SUMMARY REPORT

Re: Kolb Road: Connection to Sabino Canyon Road
Request for Feedback on Access Options

**Kolb Road: Connection to Sabino Canyon Road
Access Options Response Form Transcription**

Access Option #1

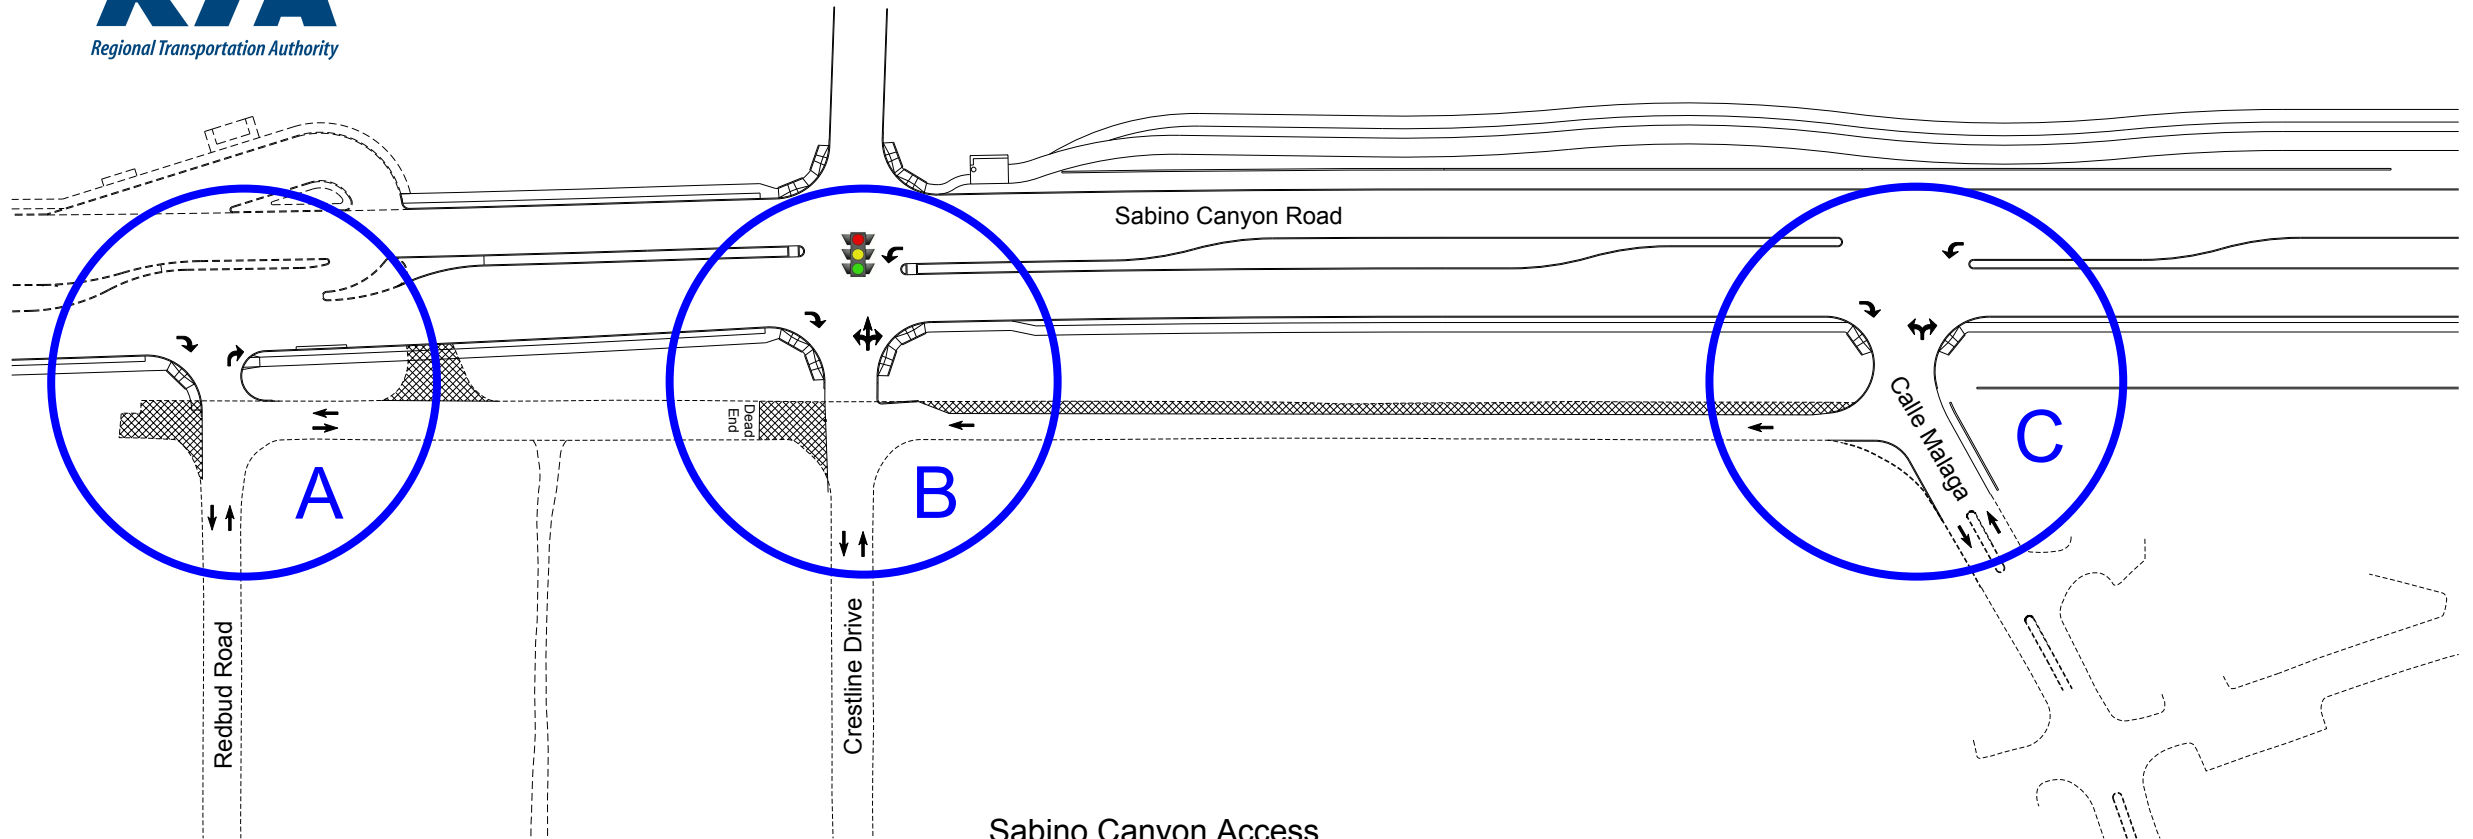
Comments
<p>OPTION #1 MOST – Ends at the end of each street make since to me. LEAST – Why can’t A + B meet at the signal?</p> <p>OPTION #2 MOST – Nothing LEAST – I think A + B access are too close, which would cause accidents. Dangerous.</p> <p>OPTION #3 Too much like option 2. I think it could be dangerous.</p> <p>GENERAL COMMENTS I think there are too many entries + exits which could cause car wrecks. I would have thought this was already cut + dried.</p>
<p>OPTION #1 MOST – All streets would have direct access. LEAST – Seems like it would encourage cut-through the most.</p> <p>OPTION #2 MOST – May discourage some cut through on Redbud, esp. with the dead end at the lighted intersection. LEAST – This may inadvertently flow more traffic down to Calle Malaga, which dead ends in Pantano II.</p> <p>OPTION #3 MOST – Appears to separate the neighborhood from heaviest traffic the best. LEAST – None of the intersections have access to the traffic signal – dangerous.</p> <p>GENERAL COMMENTS As a motorcycle rider who lives in Pantano II, direct access to the traffic light is a must for me from a safety standpoint. I do still see the potential for cut-throughs on Crestline, but I think some of that is unavoidable. The other big issues I can think of now is that there needs to be “dead end” or “no outlet” (or “local access only”) signage at or before the entrance to Pantano II > otherwise we’ll get people coming in the neighborhood & not being able to get out. We get this regularly already.</p>

<p>OPTION # 1 MOST – This option has the best access.</p> <p>OPTION #2 MOST – Could still access traffic signal</p> <p>OPTION #3 LEAST – Will be very difficult to access home</p>
<p>OPTION #1 LEAST – Least favorite option – do not want to encourage neighborhood traffic and think direct access points may increase this.</p>

<p>OPTION #1 MOST – nothing: LEAST – Deadend will cause confusion. Opening of redbud onto main street. Redbud opening mere feet from our driveway.</p> <p>OPTION #2 MOST – Redbud closed to main street. Access moved to alley location. LEAST – Deadend @ crestline will create confusion.</p> <p>OPTION #3 MOST – Excess non-residential traffic will be deterred from driving into residence because traffic light does not have full signalized access. Better flow for residential traffic on frontage road. LEAST – Nothing</p> <p>GENERAL COMMENTS Don't really have any general comments. I appreciate there being options to consider and the opportunity for feedback. I hope the feedback will be used in the decision making process.</p>
<p>OPTION #1 LEAST – Ingress/egress from Redbud directly onto Street (Redbud). Stoplight funnels people directly into neighborhood</p>

<p>OPTION #1</p> <p>MOST – Access to Redbud seems easy</p> <p>LEAST – 1. Access from Sabino Canyon to Calle Malaga – unsafe. 2. Too many openings/turn lanes. 3. Dead end @ frontage road – makes no sense?</p> <p>OPTION #2</p> <p>MOST – Design is overly complicated – may confuse drivers seems unsafe.</p> <p>LEAST – 1. Access from Sabino to Calle Malaga > unsafe. 2. Dead end on frontage road north of Crestline. 3. 1-way frontage road = no good!</p> <p>OPTION #3</p> <p>MOST – 1. 2 way frontage road – 2. Dead end removed @ Crestline.</p> <p>LEAST – 1. Access from Sabino to Calle Malaga – unsafe, no purpose > opens residents to un-needed traffic.</p> <p>GENERAL COMMENTS</p> <p>I DO understand that we need roads to help alleviate the traffic. I DO feel deeply sorry for the residents of Pantano II townhomes. I strongly encourage extra funds be allocated to build a noise barrier for these residents.</p>

Comments
<p>OPTION # 1 MOST – Easiest access to Sabino Cyn seems safest.</p> <p>OPTION #2 MOST – Easy access to Sabino Cyn LEAST – Not a safe way to get on Sabino Cyn</p> <p>OPTION #3 MOST – Nothing LEAST – No easy access from Calle Malaga</p>
<p>OPTION #1 MOST – Good for all residents to have access from their respective neighborhoods. LEAST – Live in Pantano II. Concerned we will have a lot more traffic on Calle Malaga.</p>
<p>OPTION #1 MOST – Access to light for everyone, sort of. LEAST – No access to light from Redbud.</p> <p>OPTION #2 MOST – Nothing really. LEAST – No access to light from Redbud. Only access to N. Sabino Canyon for Redbud is u-turn @ Crestline light.</p> <p>OPTION #3 MOST – Nothing. LEAST – No direct light access @ all. This gives the least access for residents to head to TV Road not good for traffic out of these neighborhoods.</p> <p>GENERAL COMMENTS I don't really like the access @ Calle Malaga. It makes for a busier intersection @ a previously quiet neighborhood access point. Generally I am not a fan of this project, but appreciate the involvement opportunity afforded to us by TDOT & RTA. I would also appreciate if the project website were up to date on the project. It appears that most of the updates were done back in March.</p>

<p>OPTION #1 MOST – Most convenient for those of us who use Calle Malaga. LEAST – Crestline Dr. is falling apart. More traffic on it could destroy it.</p> <p>OPTION #2 LEAST – Same applies. (Option #1 and 3, LEAST)</p> <p>OPTION #3 Lack of access to traffic signal would be very inconvenient – We could only go South on Sabino Canyon Rd. What would be the point of the signal?</p> <p>GENERAL COMMENTS I am glad you are keeping the frontage road. Eliminating that would effectively isolate our neighborhood.</p>
<p>GENERAL COMMENTS I live off Camino Principal and am not famaliar with the 3 streets in question, so, it will not be benificial to you for me to comment either way.</p>
<p>OPTION #1 LEAST – Full access to Sabino Cyn via Malaga. Redbud access to Sabino Cyn. Dead-end on frontage road.</p> <p>OPTION #2 LEAST – Full access to Sabino Cyn via Malaga. Redbud > Sabino Cyn access. Dead-end on frontage road.</p> <p>OPTION #3 LEAST – Full access to Sabino Cyn via Malaga. Access to frontage road only. No direct access to Sabino Cyn from Redbud or Crestline.</p> <p>GENERAL COMMENTS</p>

<p>OPTION #1 MOST – Looks easy in and easy out if your going R LEAST – May be difficult to turn L without traffic lights</p> <p>OPTION #2 MOST – With the anticipated increase in traffic, it will be easier to turn L with a traffic light LEAST – How long will the time be to turn L</p> <p>OPTION #3 MOST – Would be good if traffic isn’t too heavy LEAST – Same as Opt. 1</p>
<p>OPTION #1 LEAST – Option A grants the most potential access to Redbud Rd which is not good for us who live on the street.</p> <p>OPTION #2 MOST – Option C is in between better than A/not as good as B</p> <p>OPTION #3 MOST – B/option 3 offers us the most privacy from noice/traffic etc.</p>
<p>OPTION #1 LEAST – Don’t like deadend & one way on frontage</p>

<p>OPTION #1 You have arrows going S on frontage rd. to dead end?</p> <p>OPTION #2 How do Redbud residents get out to S. Canyon?</p> <p>OPTION #3 All Redbud and Crestline using same entrance and exit rd.?</p> <p>GENERAL COMMENTS: A petition was signed by residents several years ago to dead-end Redbud, because at rush hour, Redbud was used by T.Verde traffic to expedite travel to traffic light at T.Verde/S. Canyon. This concerns us again! Option 1 and 2 provide direct access to light for Crestline, especially. Option 3 seems best to avoid this. However, is it good to have Redbud and Crestline using same exit and</p>

Access Option #2

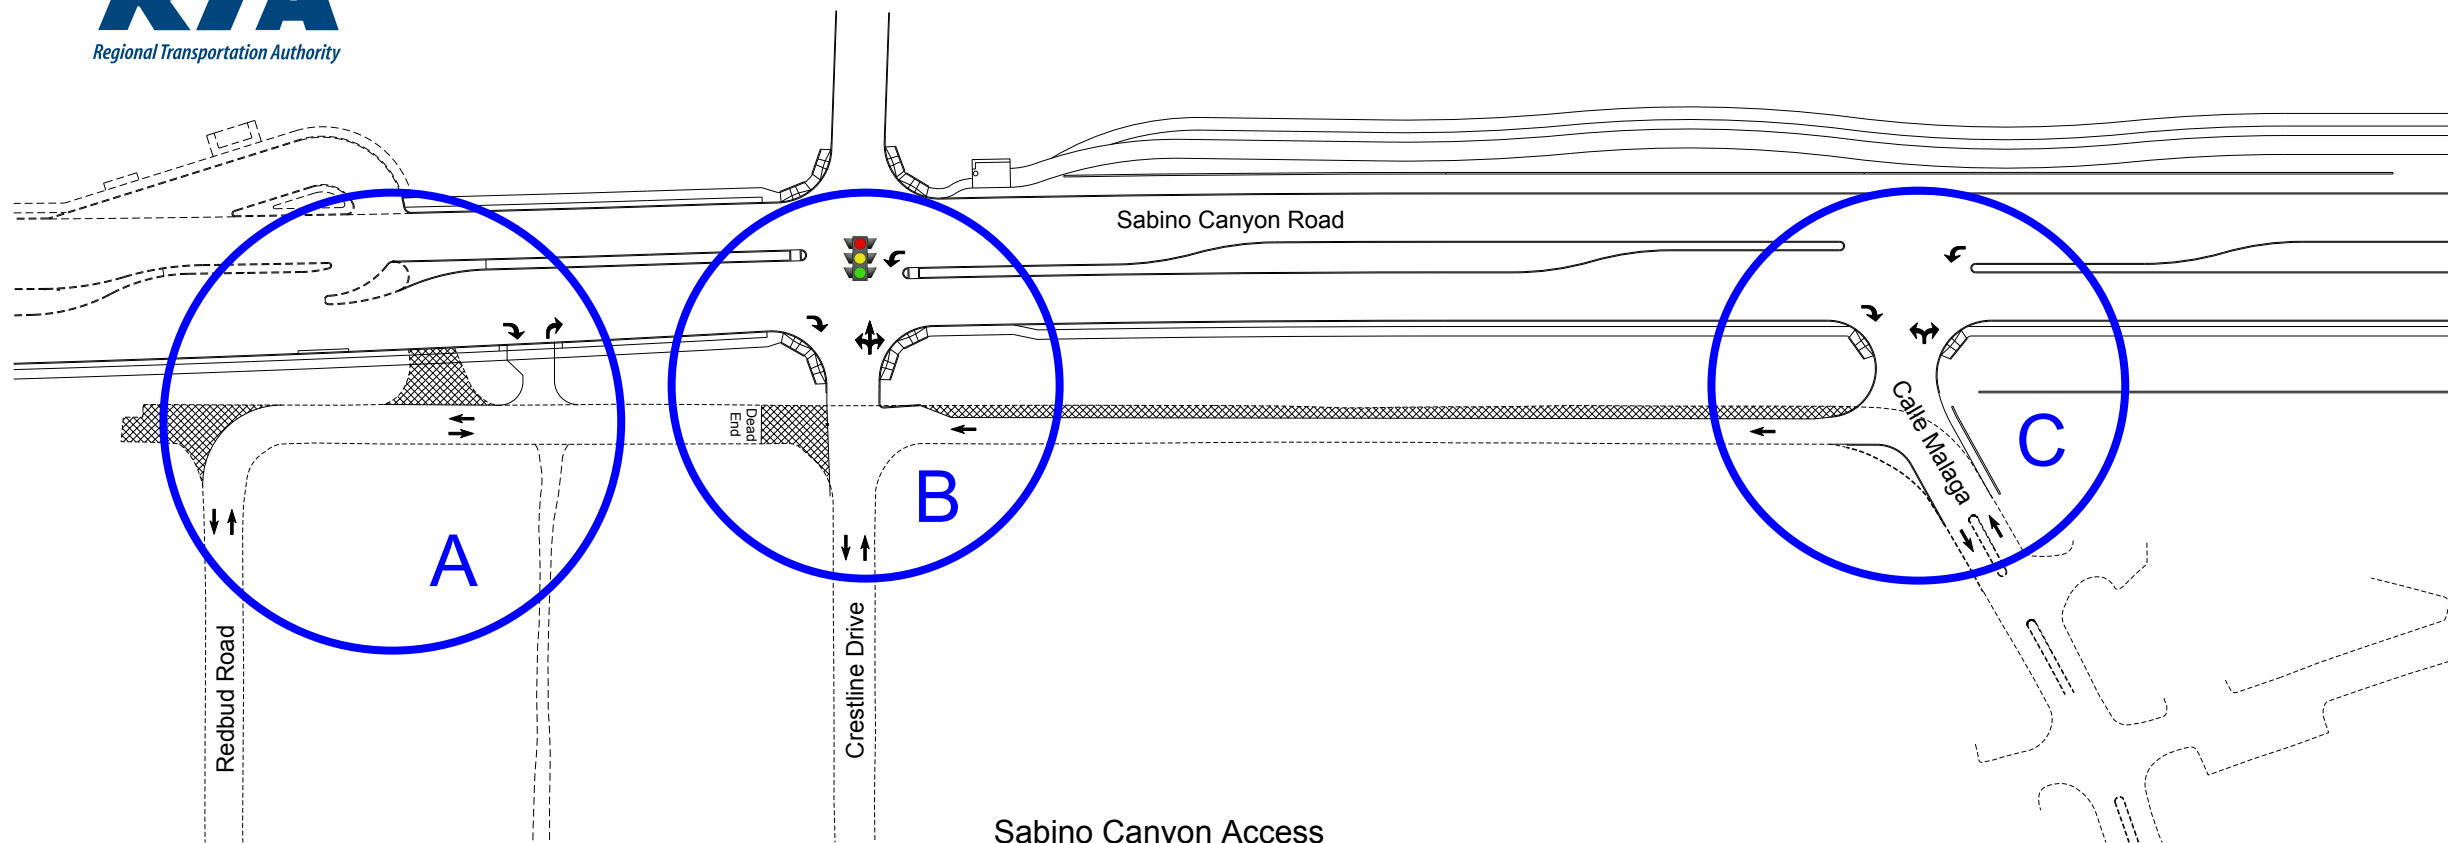
Comments
<p>OPTION #2 MOST – Less direct traffic access points to traffic signal. LEAST – Not completely separated as I prefer – still direct access that could increase neighborhood traffic.</p> <p>OPTION #3 MOST – No direct access for all 3 streets.</p> <p>GENERAL COMMENTS Thank you for asking for input.</p>
<p>OPTION #1 MOST – Direct access to Sabino Canyon Rd. LEAST – N/A</p> <p>OPTION #2 MOST – 2 roads w/ direct access to Sabino Canyon Rd. LEAST – It is not bad but a lot of traffic goes thru this area and the more direct access the better.</p> <p>OPTION #3 MOST – They can all access Sabino Canyon Rd. LEAST – No direct access.</p> <p>GENERAL COMMENTS N/A</p>
<p>OPTION #1 MOST – Nothing LEAST – We were promised in the beginning that there would be no access to Sabino from Redbud and that there would be a wall</p> <p>OPTION #2 MOST – Crestline has full signal road access and Calle Malaga full access to Sabino. Less traffic on street</p> <p>OPTION #3 LEAST – No direct access to traffic signal inconvenient for greater population using Sabino</p>

Comments
<p>OPTION #2 MOST – Same as option 1 LEAST – More difficult for Redbud to get in and out</p> <p>OPTION #3 MOST – Buffer zone for Crestline LEAST – Too much local congestion</p>
<p>OPTION #1 MOST – Will provide easiest access to my business without driving through neighborhood – most of the traffic is going to Sabino Canyon Pet Resort.</p> <p>OPTION #2 LEAST – Option #1 is better because it keeps the Redbud access further from Crestline, so my customers will be less likely to get confused + turn on the wrong street.</p> <p>OPTION #3 LEAST – My customers will have no direct access to my business + will have to drive through the neighborhood.</p> <p>GENERAL COMMENTS The majority of daily traffic to this neighborhood is to Sabino Canyon Pet Resort. It makes sense to allow easiest most direct access to Crestline Dr. without having to drive through the neighborhood. This would be the least disturbance to the residents. Option #1 is the best design.</p>

Comments
<p>OPTION #2 MOST – Entrance away from Redbud Question: Can we make a U turn @ new light to go North on Sabino? (I would like to) LEAST – Stoplight funnels traffic directly into neighborhood.</p> <p>OPTION #3 MOST – No stoplight entrance into neighborhood Question: Can we make a U turn @ new light to go North on Sabino? (I would like to) LEAST – Entrance/exit onto Sabino too close to Redbud.</p>
<p>OPTION #3 There is nothing worthwhile here. No consideration is given to homeowners at the Malaga entrance. All traffic that wanted to go north on Sabino would have to make U-turns. Is this a safety issue? The “Team” was always told this should not be considered – Is anyone listening?</p> <p>GENERAL COMMENTS Please see attached comments. Thank you. Further plans.</p> <p>ATTACHMENT KOLB ROAD: CONNECTION TO SABINO CANYON ROAD RESPONSE FORM COMMENTS</p> <p>At this time, there is no option presented that is acceptable. Please schedule a meeting with the Udall Neighborhood residents in the fall and present us with a plan that serves the neighborhood, not the RTA.</p> <p>Currently, there are many gone on a vacation or gone for the summer and their mail has not caught up with them. I have forwarded the questionnaire to those I was able to get in touch with. Renters are excluded from their opinion, although they live in the area and consideration has not been given to those who live closest to the egress/ingress points. Furthermore, human nature being what it is, votes will be made for individual conveniences without concern for the total area and the compromises that should be made for the majority. How is it that the Project Team now has the power to make this decision based on this survey? From the beginning, the Team was told that Malaga was not to be considered and to please come up with other options. So far, none are acceptable.</p> <p>It was also noted that pedestrian traffic patterns to access the park and walk their dogs were not shown on any of these options. This activity has been a very large activity for this area because of the access to the park.</p> <p>We are the ones most impacted by this road project as well as the constant rise in the cost of the project affecting our City taxes.</p> <p>Please give strong consideration to this request, Your efforts are appreciated.</p>

Comments
<p>LEAST – Remove the dead end from Redbud to Crestline Dr. because it puts all the pressure of traffic onto Crestline.</p> <p>OPTION #2</p> <p>LEAST – Remove dead end from Redbud to Crestline. It is a safety hazard for police, fire dept etc. & unfair to pass traffic from directly out of Udall Park to Crestline.</p> <p>OPTION #3</p> <p>LEAST – Hope there will be in sidewalk on the west side of the light, so walkers from Redbud & Crestline, Calle Malaga to cross the street to the park.</p> <p>GENERAL COMMENTS</p> <p>Also, the house on the corner of Crestline – he has to use Sabino Canyon to get into his garage & driveway and Crestline Drive to enter the front of his house. Thank you for asking our opinion & sending out the options to us. You have ruin our neighborhood area & our wild life with all the construction going on & the removal w/ the “desert ava” between Crestline & Udall Park. You have made S.C. south widen & there is no way for us to make a left hand turn now without a light for safety.</p>

Comments
<p>MOST – Makes most sense. Alley access for utilities/backyards but no racetrack on frontage rd. because of deadend.</p> <p>OPTION #2 MOST – Nothing. LEAST – Increases distance driven to Redbud for no reason when direct access to Redbud should be aligned with Redbud not at alley.</p> <p>OPTION #3 MOST – Nothing. LEAST – Difficult to access SBR northbound w/o U Turn or xing traffic. Frontage raod will again become a racetrack for townhome traffic. Will need traffic bumps to keep speed under control.</p> <p>GENERAL COMMENTS Whatever happens the “townhome people” outnumber home owners on Redbud + Crestline – this really impacts the homeowners more than “townhome people.” Very evident “townhome people” can’t comprehend written regulations – i.e. STOP – 98% don’t stop. /Speed limit means no less than – 20 miles over speed limit is okay.</p>
<p>OPTION #1 MOST – Nothing LEAST – all streets have direct access to Sabino Canyon impacting our neighborhood with unwanted traffic</p> <p>OPTION #2 MOST – Better than one LEAST – Why is there a need for a traffic light? -> If we have access at “C”?</p> <p>OPTION #3 MOST – no access from Redbud LEAST – People are going to take the shortcut down Crestline to avoid intersection at Sabino Canyon & Tanque Verde causing traffic and pollution</p> <p>GENERAL COMMENTS I have been opposed to project since the beginning. It is the devaluing and destruction of many neighborhoods with no long term benefit for anyone. How can you construct a road across a toxic garbage dump sealed for 30 yrs? It is a known fact that auto pollution harms babies, children and pregnant women not to mention the rest of us.</p>

Comments
<p>OPTION #2 LEAST – Don't like deadend & one way on frontage</p> <p>OPTION #3 LEAST – This would be most preferred if Crestline had direct access to light/Sabino Rd</p> <p>GENERAL COMMENTS Redbud should have direct access to light.</p>
<p>OPTION #1 MOST – Seems to relieve traffic in all areas. May reduce flow on Crestline due to other access points. Light for access from Crestline to go south on Sabino Canyon. LEAST – Noise and disturbance for neighborhood.</p> <p>OPTION #2 MOST – Access point for Crestline traffic to go south on Sabino Canyon. Some relief for Redbud residents to avoid light. LEAST – Noise and disturbance for neighborhood. Access road between Redbud + Crestline seem too close – potential danger.</p> <p>OPTION #3 MOST – Seals in neighborhood and may best protect against noise. LEAST – Makes access onto Sabino Canyon difficult with a potential bottleneck and the need to make a U-Turn at “Crestline” light. Too dangerous.</p> <p>GENERAL COMMENTS We have a quiet neighborhood and would like to retain that quality as much as possible. I do not want traffic to increase significantly on Crestline and am concerned that our once peaceful ability to walk to Udall Park is gone forever. Sabino Canyon has been an important point of egress and we will probably need the light as the N-bound access is critical and we don't know how busy this new Sabino Canyon will be.</p>

Comments
<p>OPTION #2 MOST – Easy access to traffic signal. LEAST – Access for general public not reduced enough = wear and tear on roads, crime, safety issues possibly.</p> <p>OPTION #3 MOST – Limits cut thru traffic protects homeowners from excess traffic, crime. LEAST – Direct access to Calle Malaga off Sabino Canyon Rd = possible safety, crime issues.</p>
<p>OPTION #1 MOST – Traffic to small roads are spread evenly to Redbud, Crestline, and Calle Malaga. LEAST – A lot of traffic going to small road. (Redbud, Crestline, and Calle Malaga.)</p> <p>OPTION #2 LEAST – A lot of traffic going to small road. (Redbud, Crestline, and Calle Malaga), especially Crestline Drive. Neighborhood will be very noisy.</p> <p>OPTION #3 MOST- Traffic from Sabino Canyon doesn't go directly to small road but still access going to it. Less noisy than other two options.</p> <p>GENERAL COMMENTS Basically we don't like busy traffic from Sabino Canyon road passing thru small roads in our neighborhood. At the rush hour there are a lot of cars going thru Tanque Verde to Sabino Canyon making long lines on the intersection. We concern if these lines move into our small roads around the house making it unsafe for our children and pets, which are used to quiet environment with minimum traffic.</p>
